Manufacturer's Communication to Dealer

MCD-003 Repair Instructions

Models Involved: 2016 – 2023 Allegro Open Road, Allegro RED 360, Allegro RED 340, and Phaeton Motorhomes equipped with an optional overhead bunk bed.

Purpose: Provide an additional latch if the operator of the motorhome does not properly latch the primary latch.

Figure 3a

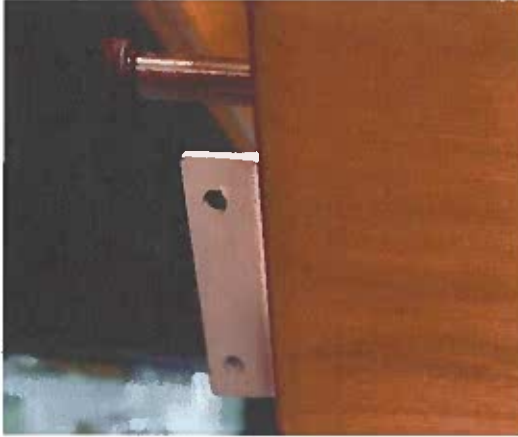
3. Locate the white bucket on the driver's side of bunk (figure 3a). Secure bunk bracket 2 in position using the bolts, lock washers and nuts from the hardware kit. Bunk bracket 2 should be placed over bracket using the existing holes (figure 3b).
